Proposed Modified Works 04 S4.55

S4.55 APPLICATION TO MODIFY DA

Project: PROPOSED ALTERATIONS
+ ADDITIONS

At: 54 HERBERT AVE. NEWPORT 2106
Lot 147 / DP 13457

Drawing: PROPOSED SITE PLAN

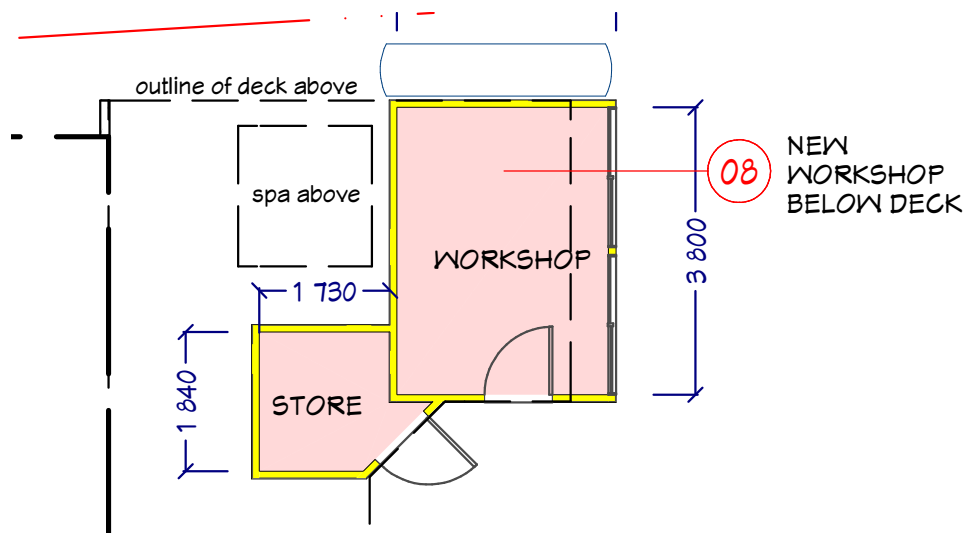
- Existing deck to be rebuilt in steel framing (same size as original DA)
- Deck-to-garden stairs rotated 90 degrees and relocated to the east side of the deck.

- Chamfer corner to be added to deck corner where stairs were before
- Awning roof to be extended across the full width of the deck (same depth as original DA, foreseen in structural and hydraulic design)

- New Skylight to Study
- Fixed window above the double door in dining space to be relocated to living space + installed vertically
- Addition of a small freestanding fireplace in the living room (Nectre N15)

- Workshop with storage to be added under the north section of the deck.
 - Same width as the deck section
 - extending approx 55 cm out to the north below the front line of the existing deck

- sits well behind the north line of the buildings at Herbert Avenue numbers 48 and 50.
- Internal changes to bedroom, robe and ensuite + modify ensuite window
